NAME				<b>Sensors, Interconnect and Power</b>	
				CIRCUIT DIAGRAM	
REVISED				SCALE	FREE
DATE	DATE	DATE	DATE	PCA PN 50-28318 rev 2	
DRAWN	DESIGNED	CHECKED	APPROVED	PCB PN 50-28316 rev 2	
				1/3

NAME				ADC	
CIRCUIT DIAGRAM				SCALE FREE	
REVISED		DATE		PCA PN 50-28318 rev 2	
DATE	DATE	DATE	DATE	2	
DRAWN	DESIGNED	CHECKED	APPROVED	PCB PN 50-28316 rev 2	
				3

NAME				<b>Micro Controller</b>	
				CIRCUIT DIAGRAM	
REVISED				SCALE	FREE
DATE	DATE	DATE	DATE	PCB PN 50-28316 rev 2	
DRAWN	DESIGNED	CHECKED	APPROVED	PCB PN 50-28316 rev 2	
				3	3

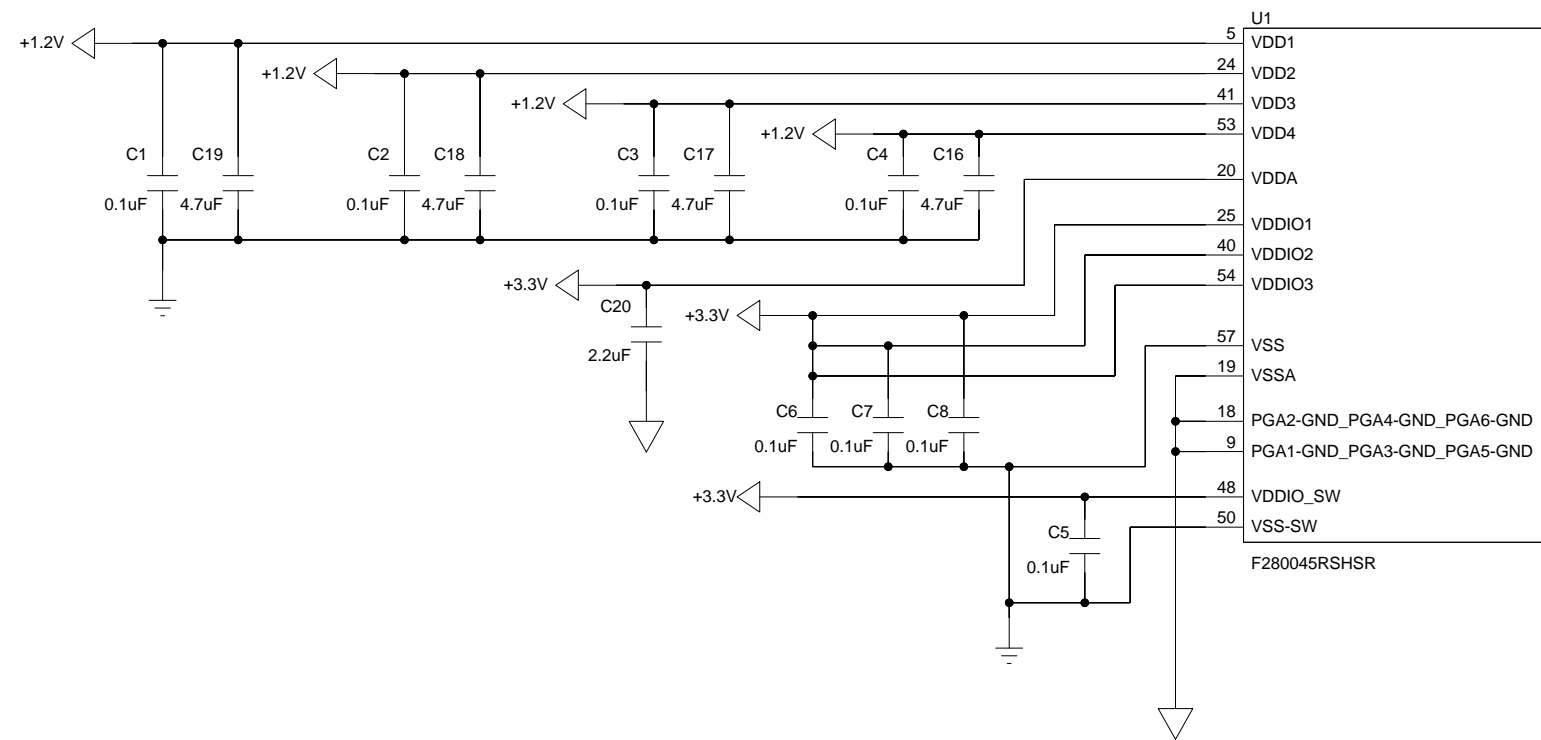
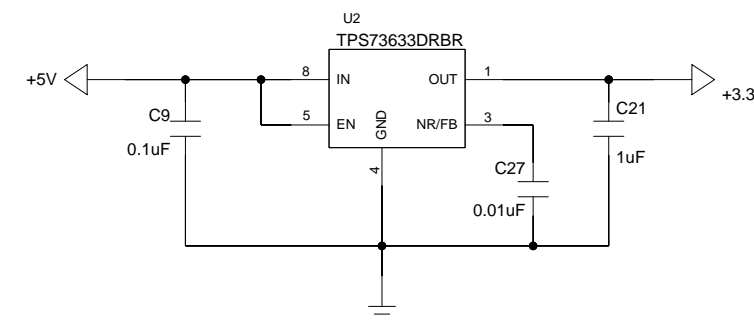
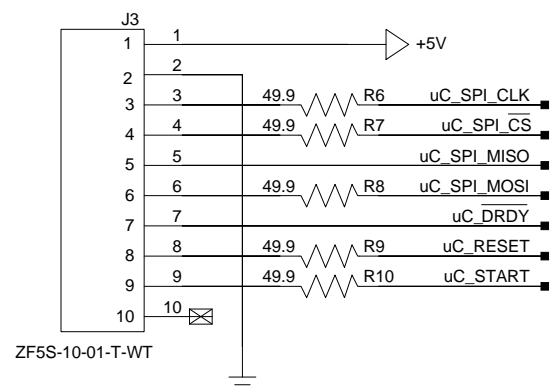
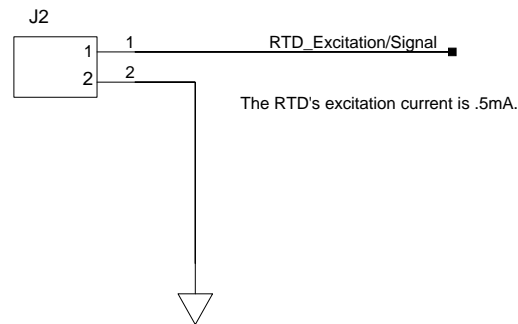
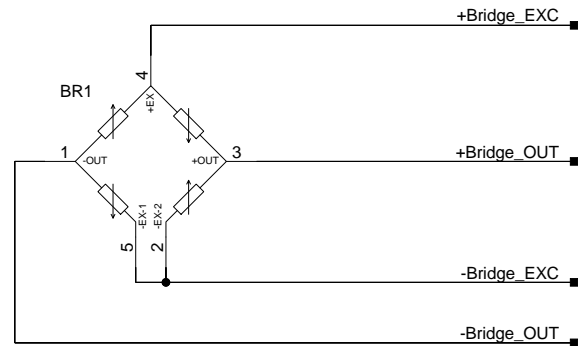
NOTE 6/6/2022: rev 2 corrected errors in the power supply circuitry. VDDIO\_SW was not connected to VDDIO. VDDIO\_SW is require to be connected to VDDIO. +3.3V was connected to VDD. +3.3v should never be connected to the VDD pins. In this configuration, the internal VREG is supplied by VDDIO and generates the 1.2v required to power the VDD pins. Change the LDO from TPS73133DBVR to TPS73633DRBR. An increase of current output from 150mA to 400mA.

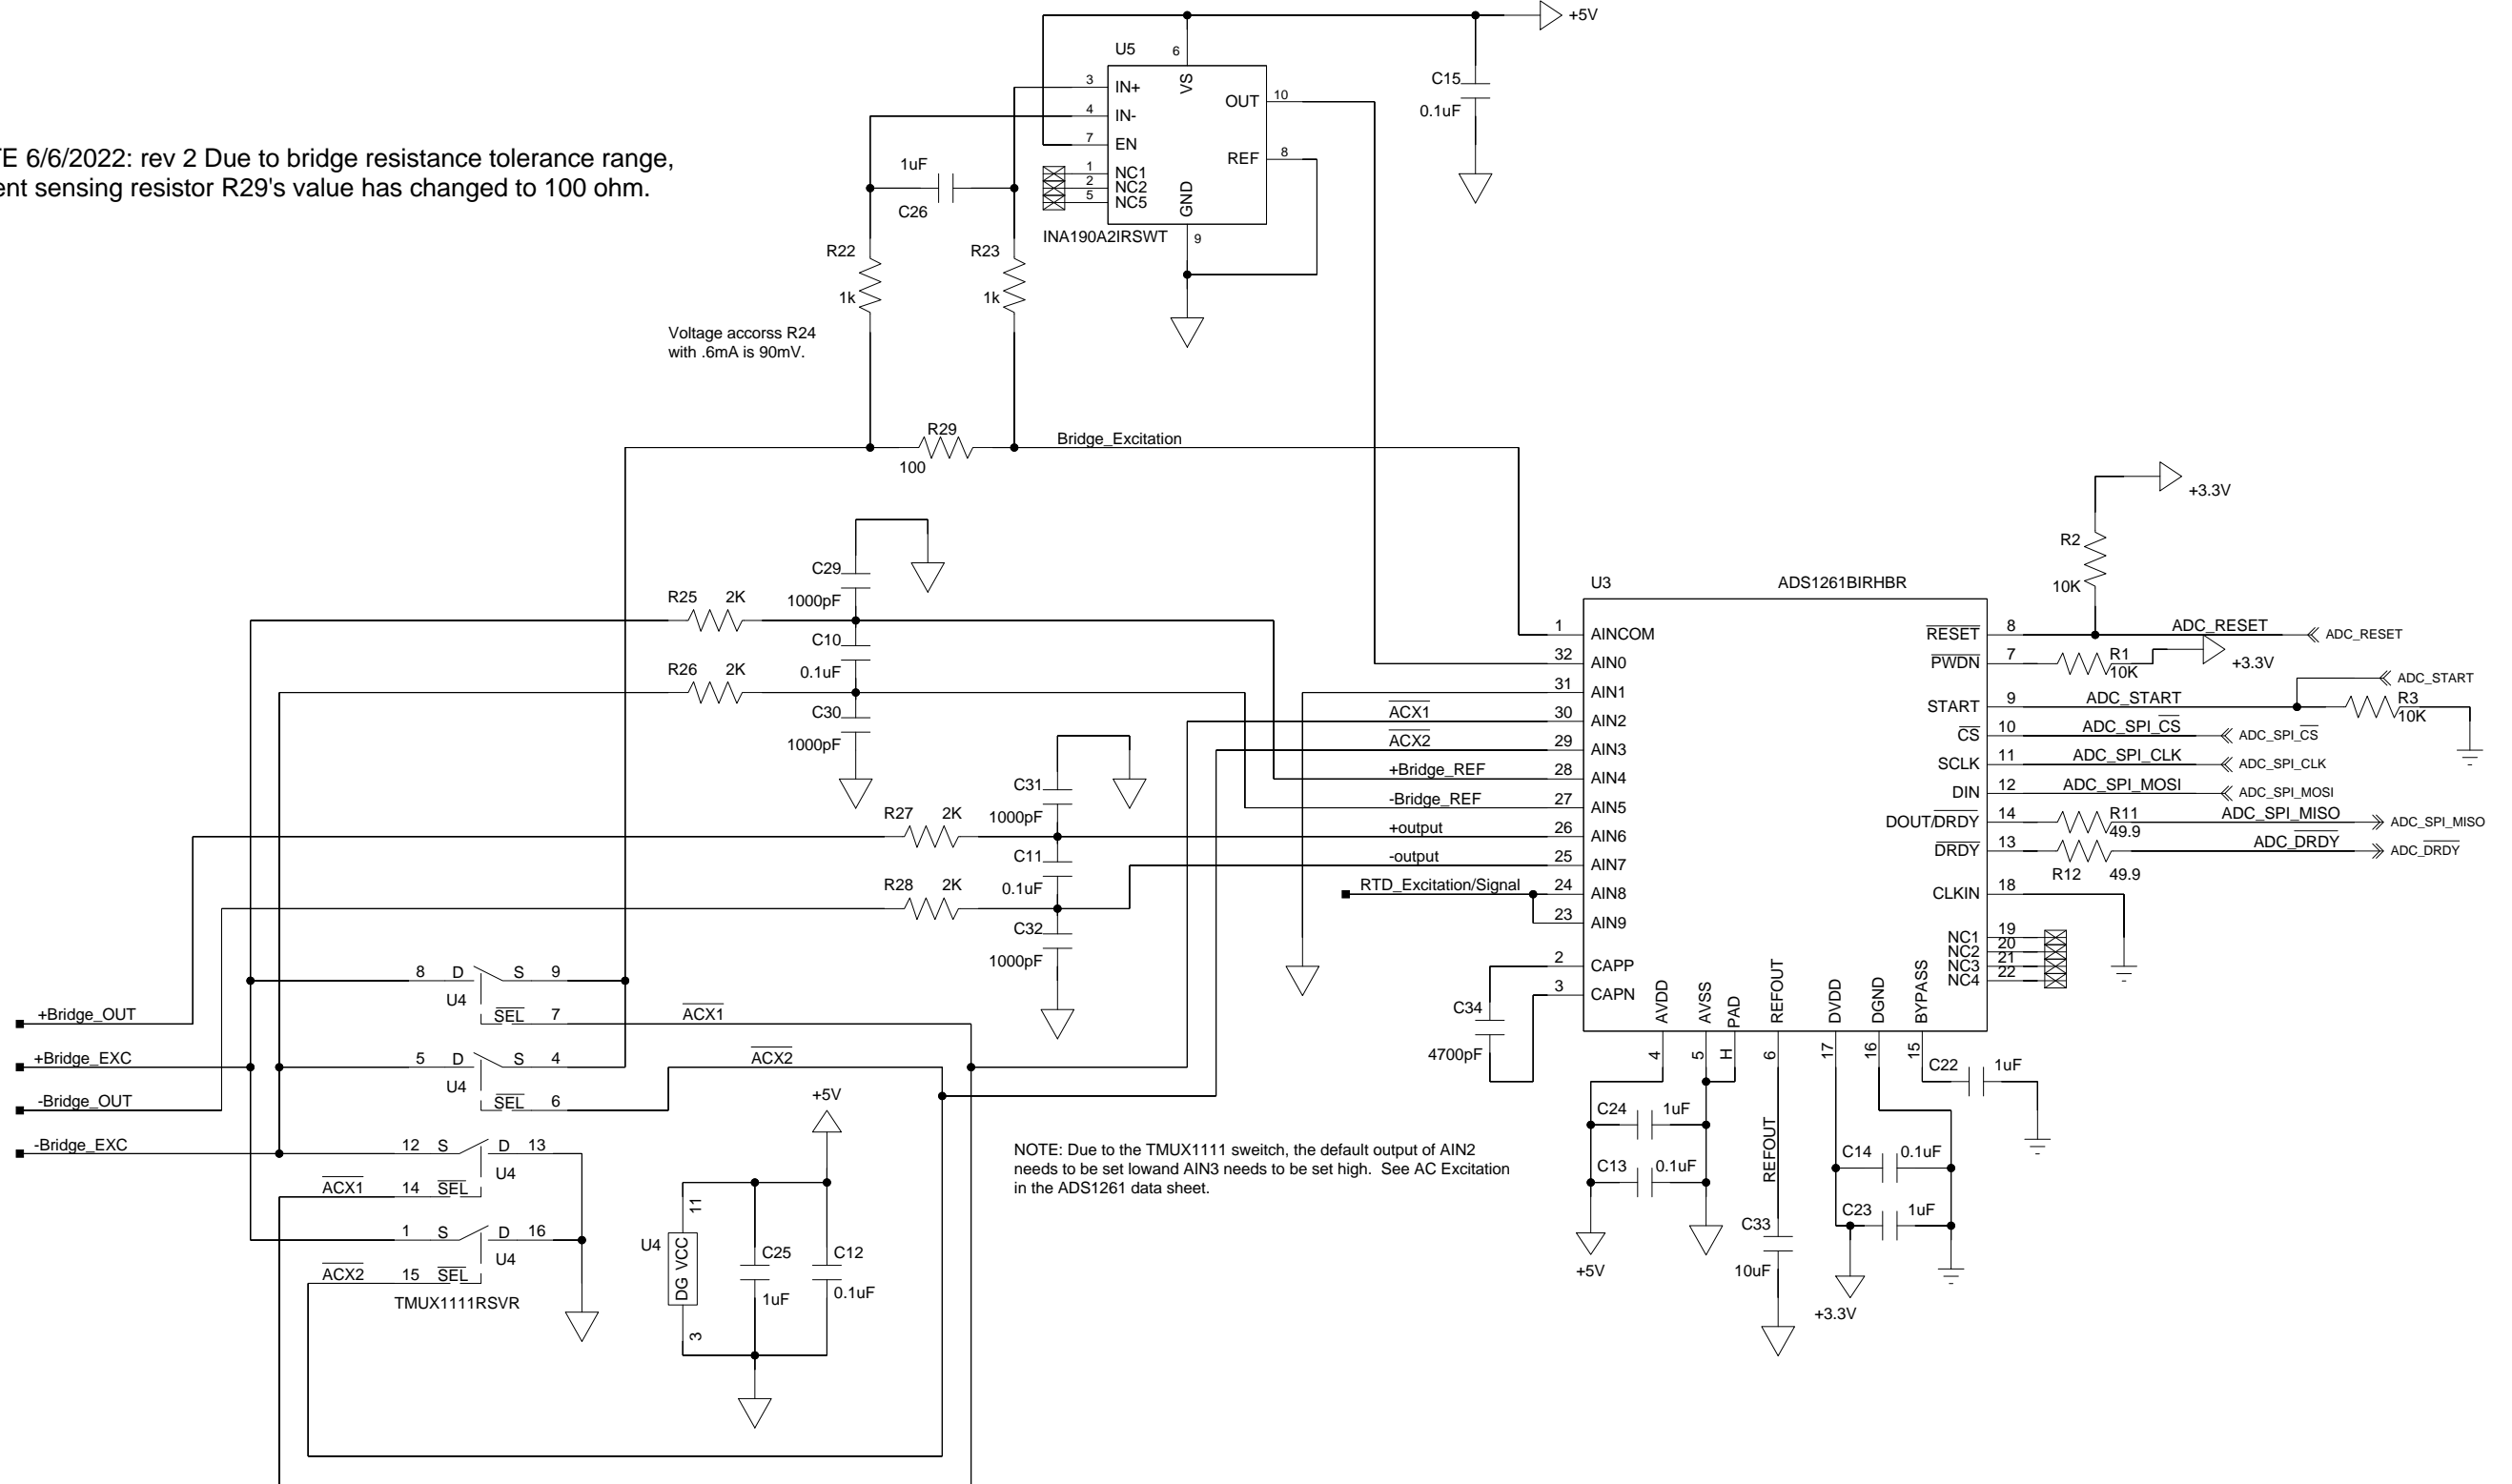
NOTE 6/6/2022: rev 2 Due to bridge resistance tolerance range,  
 current sensing resistor R29's value has changed to 100 ohm.

The INA190A2 current amplifier is a 50V/V device.  
 With an excitation current of .6mA, the resulting voltage drop across R29 will be 60mV. The output will be 3.0V.

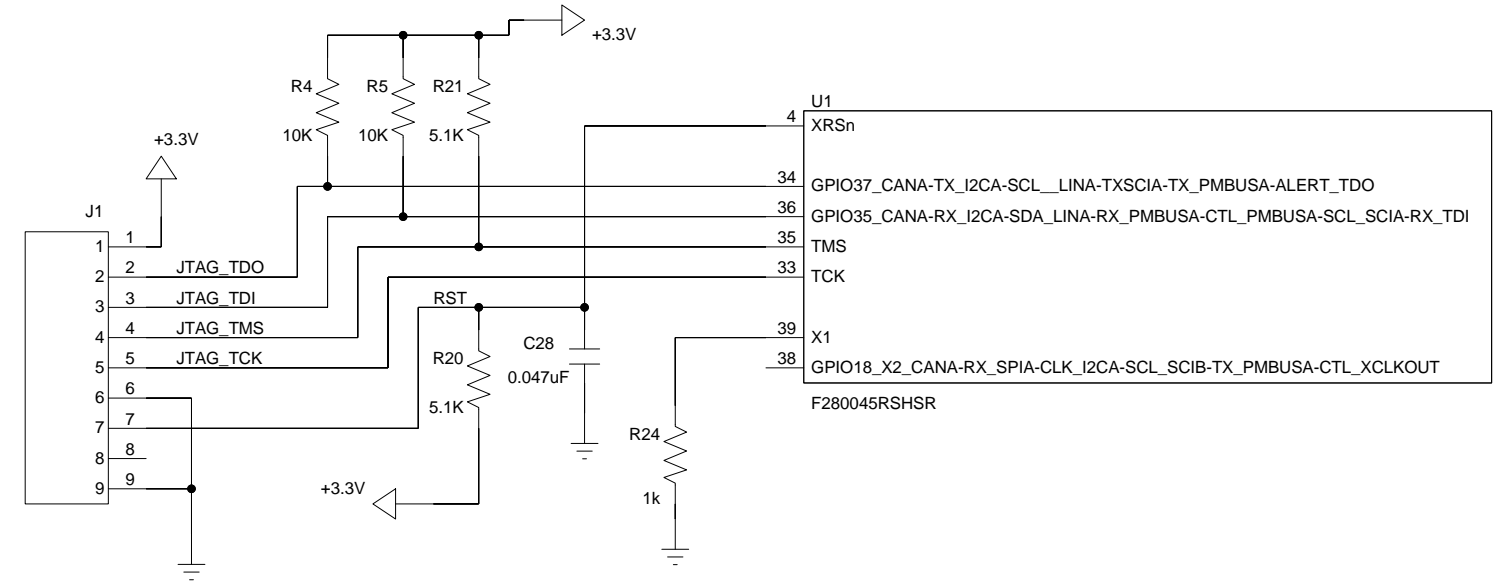
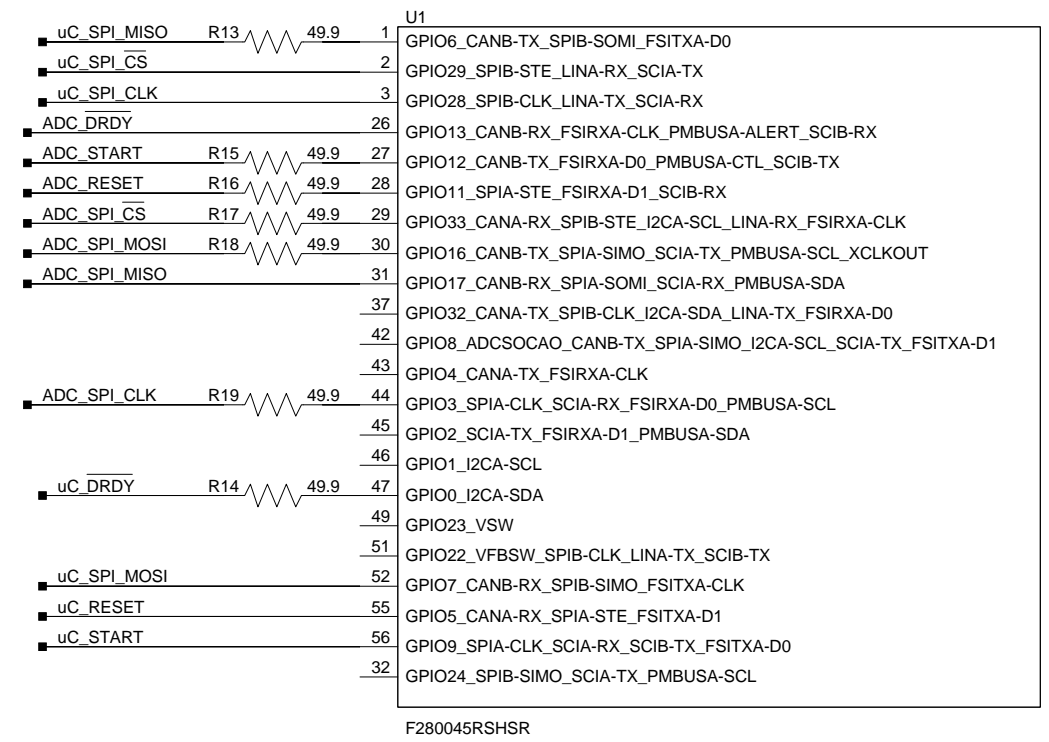
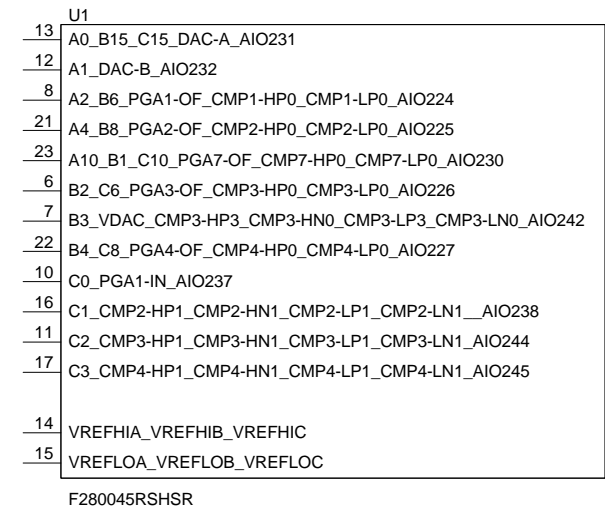
NOTE 6/6/2022: rev 2 corrected error in IO.  
uC\_DRDY was connected to GPIO\_VFBSW. This pin should be left open.  
Moved uC\_DRDY to GPIO0 (pin 47).
